Subject: Windsor Nuclear Fuel Manufacturing Facility
License Amendment Request

Combustion Engineering requests that the license for its Windsor Nuclear Fuel Manufacturing Facility be amended. The amendment seeks authorization to operate a centrifuge relocated as part of the facility revitalization program.

COMBUSTION ENGINEERING, INC.
WINDSOR NUCLEAR FUEL MANUFACTURING
DOCKET NO. 70-1100, LICENSE NO. SNM-1067
AMENDMENT REQUEST
LIST OF AFFECTED PAGES

COMBUSTION ENGINEERING, INC.
WINDSOR NUCLEAR FUEL MANUFACTURING
DOCKET NO. 70-1100, LICENSE NO. SNM-1067
AMENDMENT REQUEST
PROPOSED CHANGE PAGES

Figure 8.14

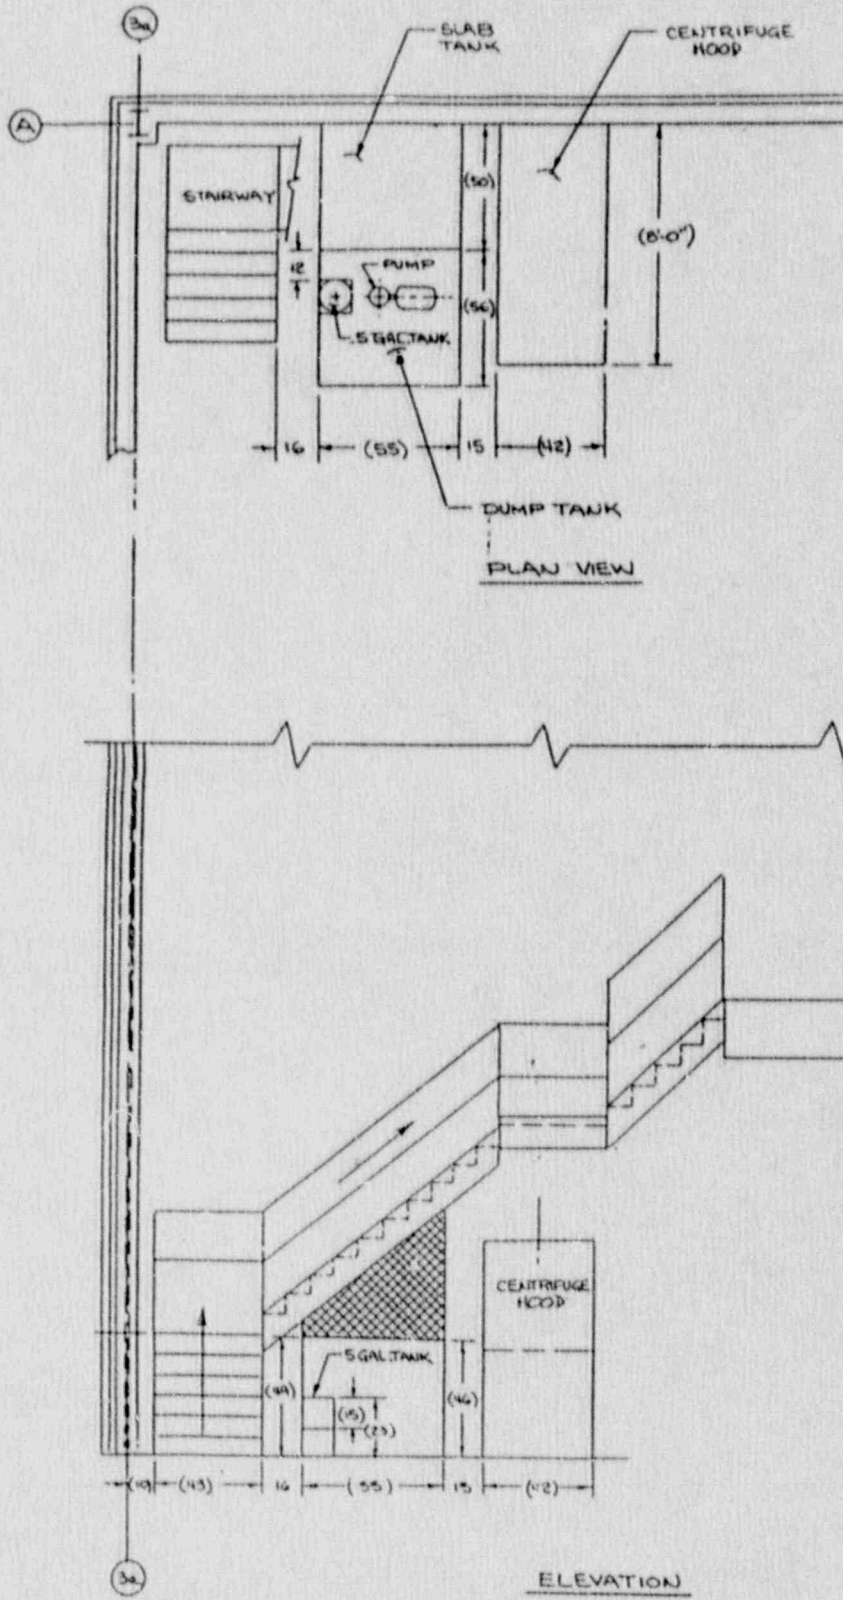
Building 6. The centrifuge bowl has a capacity of 23 liters. All auxiliary containers (e.g., overflow can and fill tank to closed system) have a capacity of less than or equal to 5 gallons and are spaced at least 12 inches from each other or other containers of fissile material.

The centrifuge is located in an open face hood. The two regions of the hood to the right and left of the centrifuge are mass limited stations employed for cleaning of the centrifuge and processing of waste solids. The critical volume for water reflected optimally moderated 5.0 wt% U-235 is 31.0 liters based on Figure I.D.10 of UKAEA AHSB Handbook 1. Applying a safety factor of 1.3 results in a safe reflected volume of 24 liters. Since the centrifuge has a capacity of 23 liters, the centrifuge is considered a safe unit. The centrifuge is cleaned periodically, as necessary, to permit continued operation.

The slab storage tank is 4 inches thick and supported in a nearly horizontal plane approximately 4 feet off the floor. The square container has a mesh barrier around it so as to prevent any significant moderator material from approaching either slab face. Consequently, the slab storage tank is a safe, partially reflected container. Solids from the centrifuge are placed in safe geometry containers, dried in an oven within the hood, and then stored elsewhere for further disposition. Dirty scrap is handled under the SIU mass limits defined in Chapter 4 of Part I. Figure 8.14 shows the geometry of the centrifuge components.
